ADDENDUM NO. 4
TO THE
PLANS AND SPECIFICATIONS FOR
REHABILITATION OF LIFT STATIONS #1 AND #3
FOREST RIDGE SUBDIVISION
OAK RUN DEVELOPMENT
DAHINDA, IL

ADDENDUM #4

OAK RUN LIFT STATIONS #1 & #3

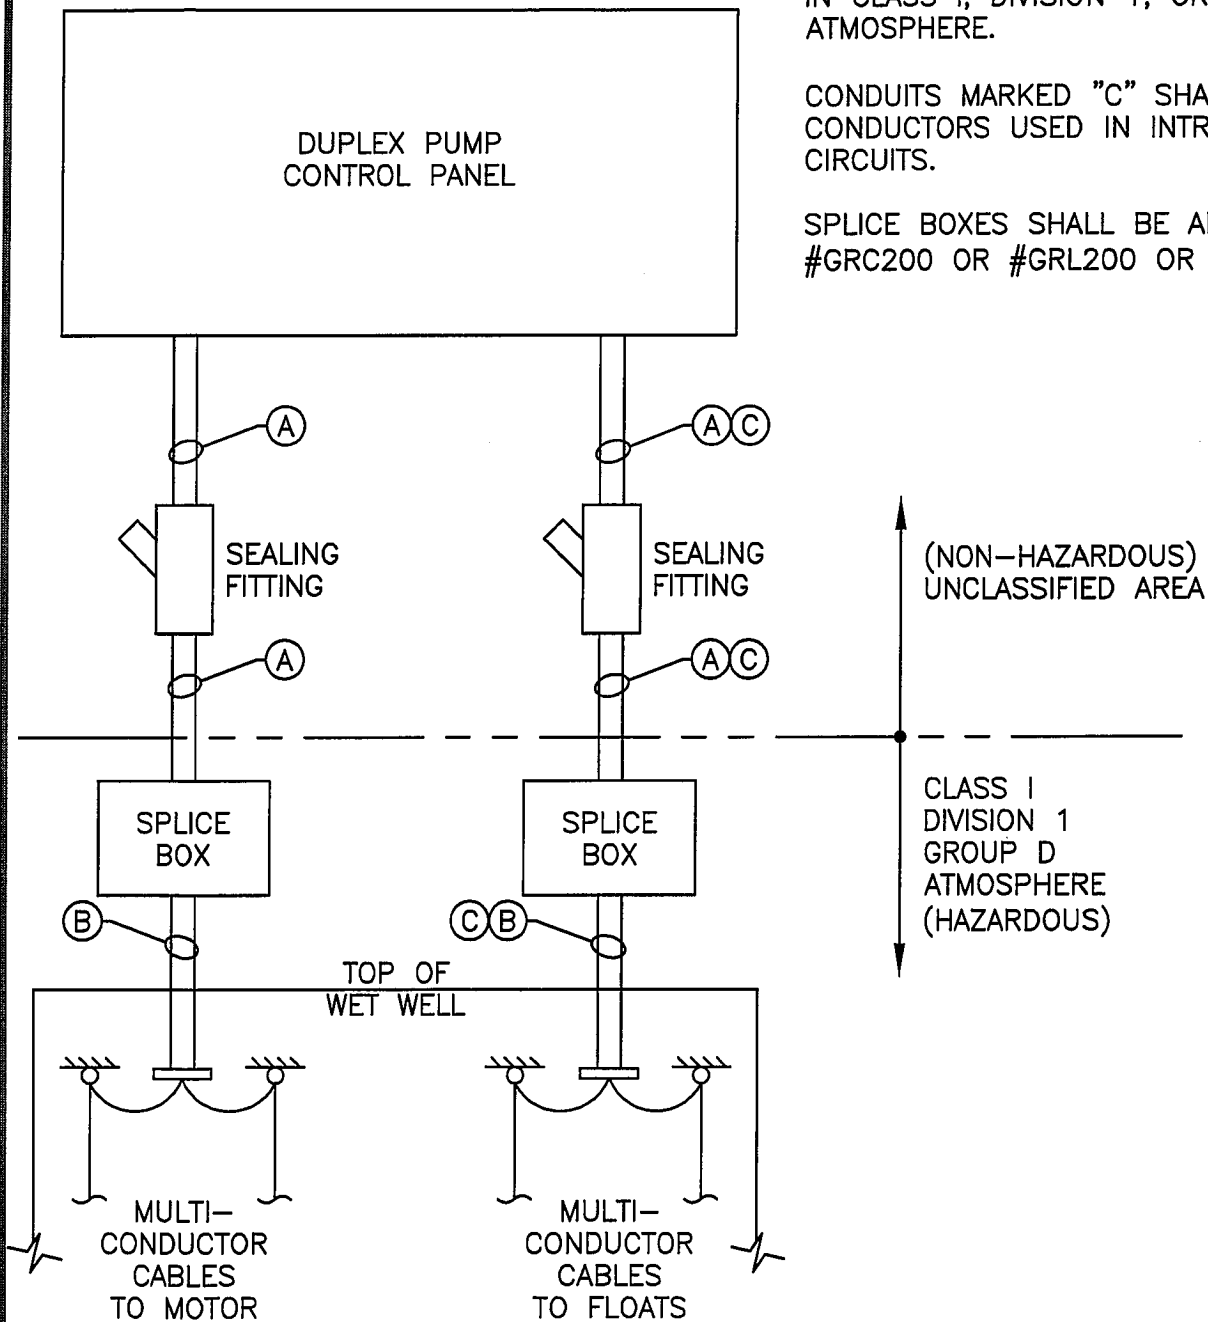
1. **Sheets 5 & 6 of 6** – Add the enclosed sketch to these sheets.
2. **Sheet 5 of 6** – Add the following note:
"Furnish and install a weather-proof, fixed-mounted receptacle for plug and cord connection of a portable engine generator. Furnish and install conduit and wire as required to connect the receptacle to the "Emergency" side of an existing manual transfer switch. This receptacle, which is for Lift Station #1, shall match the manufacturer and ampere rating of an existing receptacle located at Lift Station #3. The receptacle shall be normally de-energized and shall be arranged for reverse service from the energized plug body connect to the portable engine generator."

ADDENDUM #4 NOTES:

CONDUITS MARKED "A" SHALL CONTAIN ONLY SINGLE CONDUCTOR WIRES.

CONDUITS MARKED "B" SHALL CONTAIN ONLY MULTI-CONDUCTOR CABLES SUITABLE FOR USE IN CLASS I, DIVISION 1, GROUP D ATMOSPHERE.

CONDUITS MARKED "C" SHALL CONTAIN ONLY CONDUCTORS USED IN INTRINSICALLY SAFE CIRCUITS.

SPLICE BOXES SHALL BE APPLETON CATALOG #GRC200 OR #GRL200 OR EQUIVALENT.
